March 31, 2003
Work Plan 0278.W1 addendum

SUBJECT: SUBSURFACE INVESTIGATION WORK PLAN ADDENDUM
Pacific Rolling Door
15900 Worthley Drive
San Lorenzo, CA

FIGURE 1
SITE PLAN - PROPOSED INVESTIGATION
 Pacific Rolling Door
 15900 Worthley Drive
 San Lorenzo, California

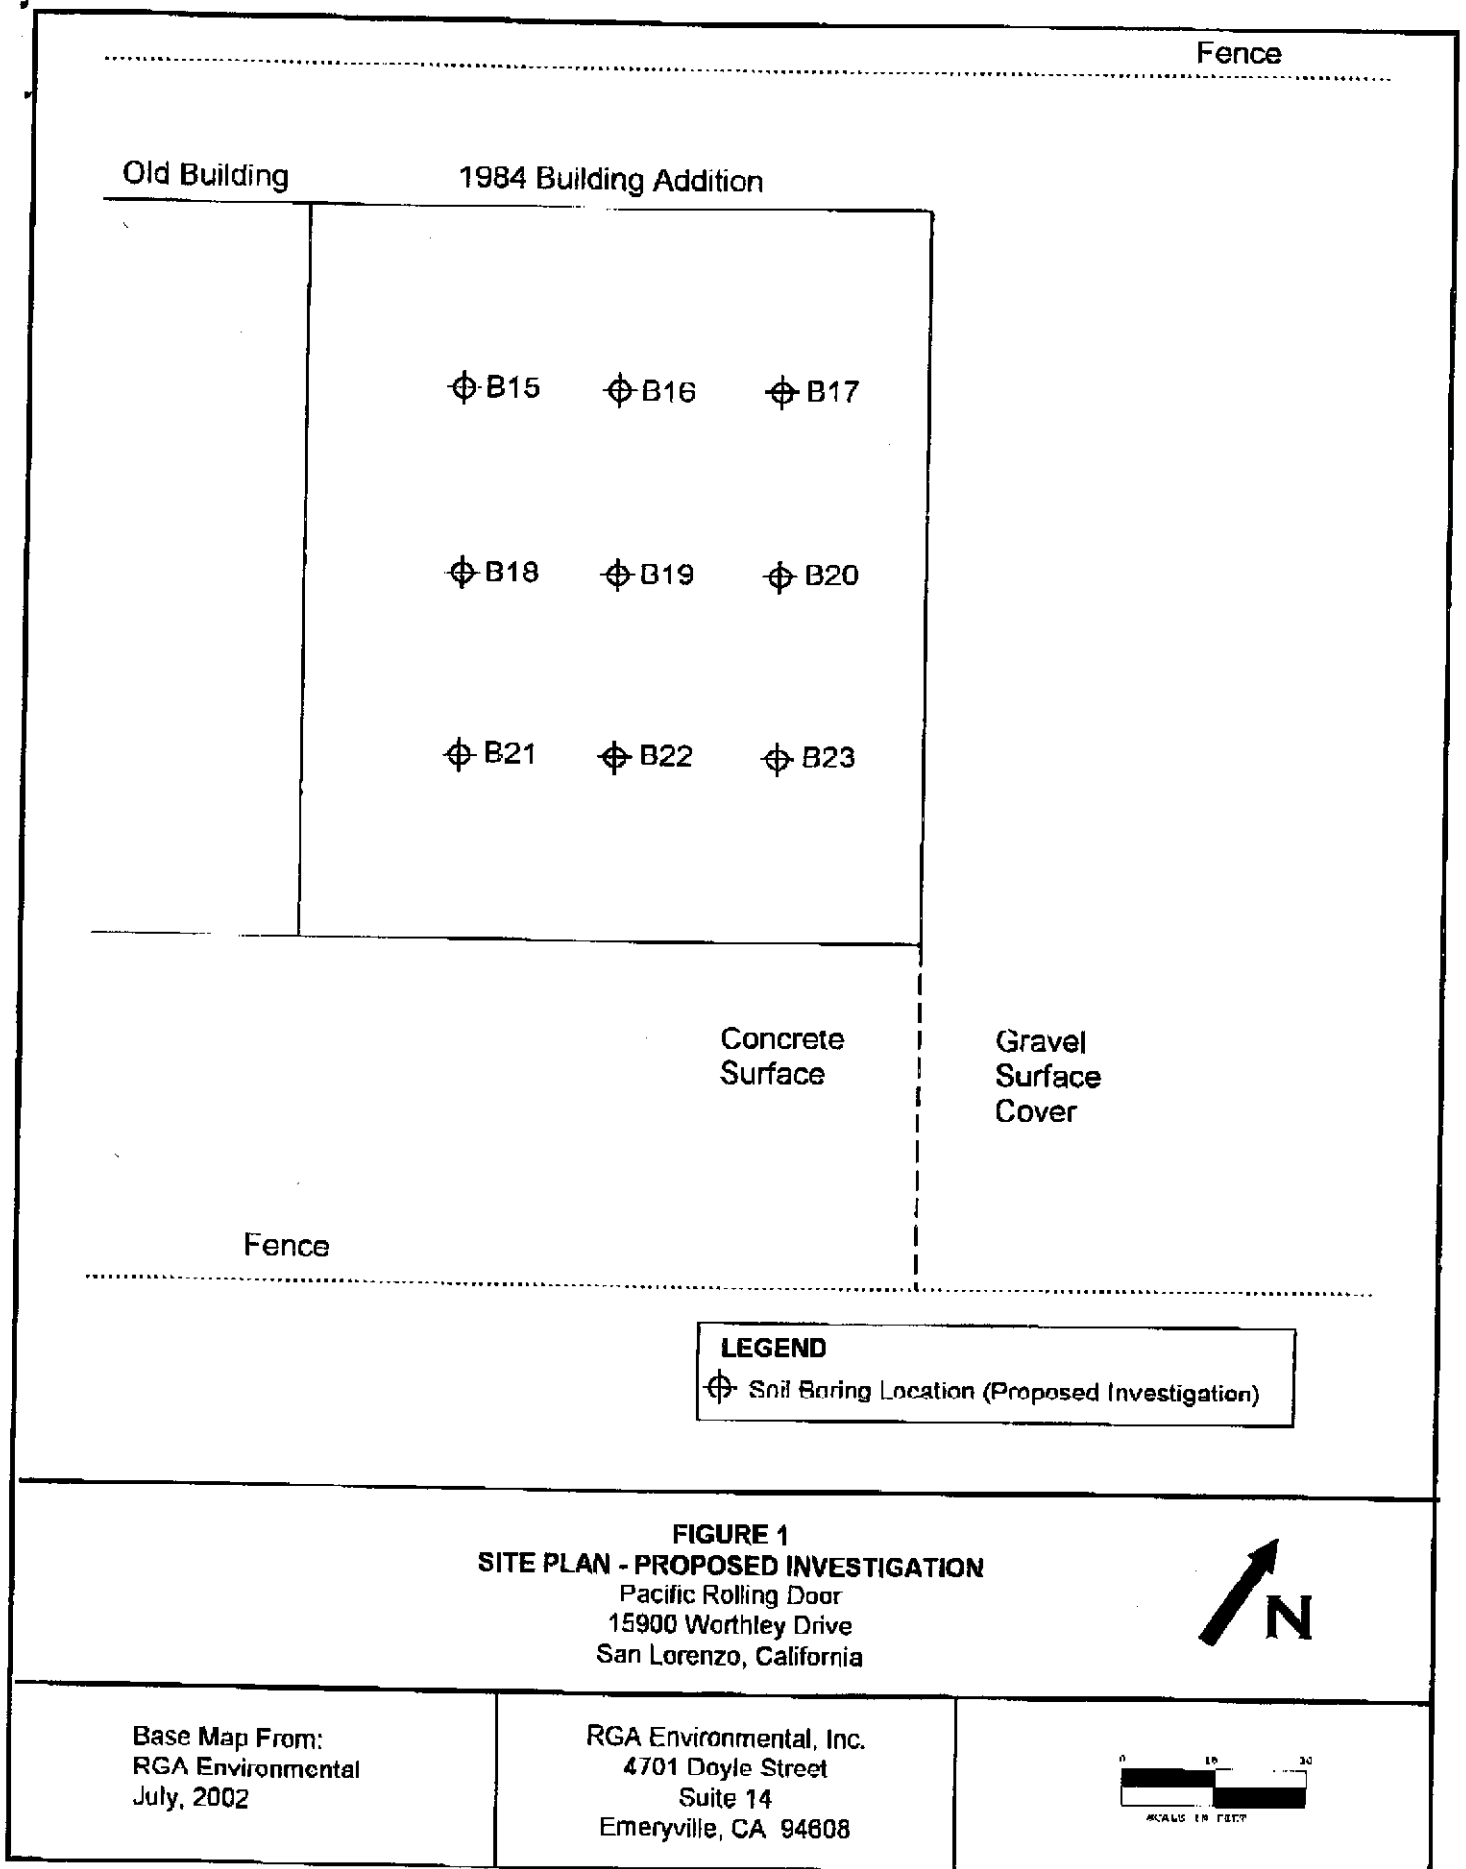
In accordance with your comments, the work plan 0278.W1 has been modified to show the hand augering of nine soil borings, instead of five. Furthermore, if the photoionization detector (PID) reads above 20 ppm on any soil sample, the sample will be analyzed for Volatile Organic Compounds (VOCs) by EPA Method 8260. If none of the samples have PID readings above 20 ppm, then only the shallow sample from borehole B19 will undergo VOC analysis by EPA Method 8260. A revised Site Plan showing the proposed drilling locations, designated B15 through B23, is attached to this work plan addendum as Figure 1.
